Aesthetic Assessment & Review of Orderly Development

Project Location: Upper Loveland Road, Norwich, Vermont
Project Size: 500kW
Prepared For: Vermont Department of Public Service
Prepared By: Lucy Thayer, PLA
TCE Project #: 22-068

May 29, 2022

Image 1. Exhibit NUL MS-2, C-100 Site Plan retrieved from the ePUC website

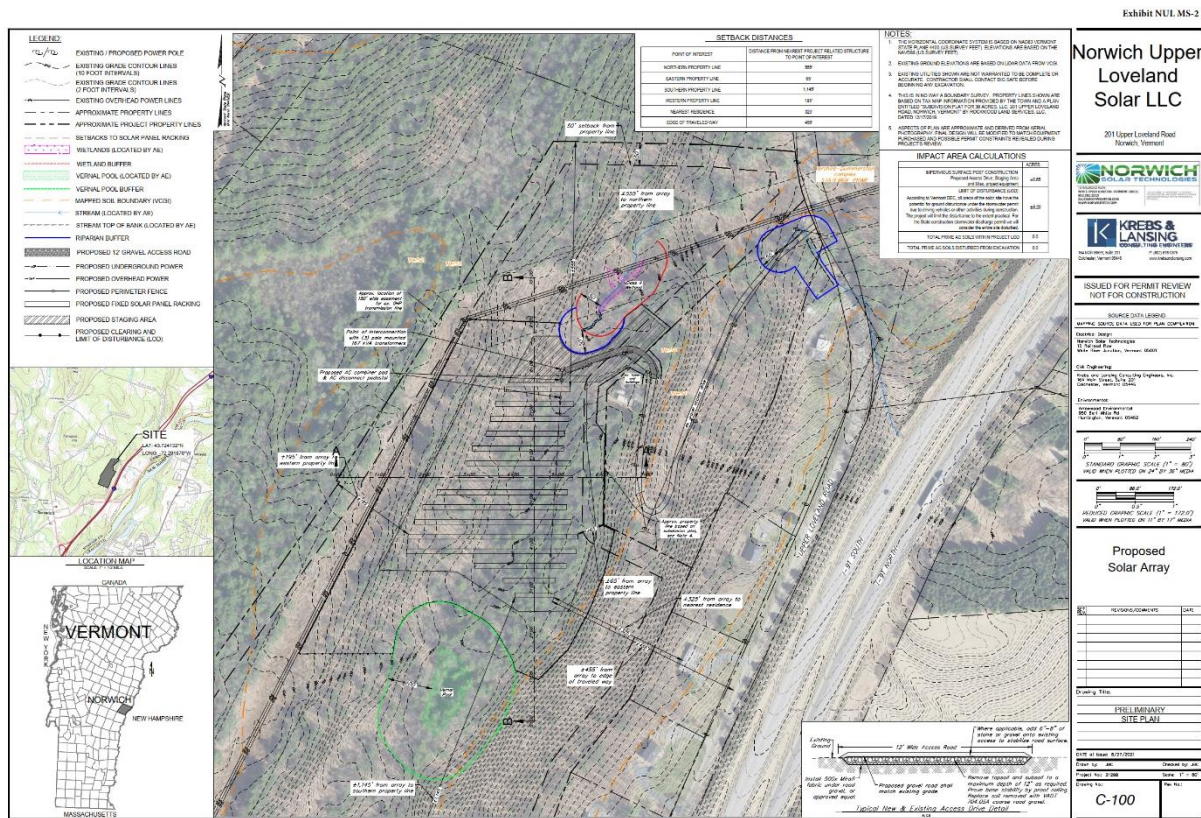
The C-100 Site Plan, Exhibit NUL MS-2, overlays the Project design over aerial imagery and it may be beneficial for the Applicant to more accurately identify what trees will be removed and what trees will remain, as the extent of these impacts and clearing is not fully clear from the aerial image. Based on the C-100 Site Plan, it appears that some evergreens may remain that would buffer the Project from offsite views to the east.
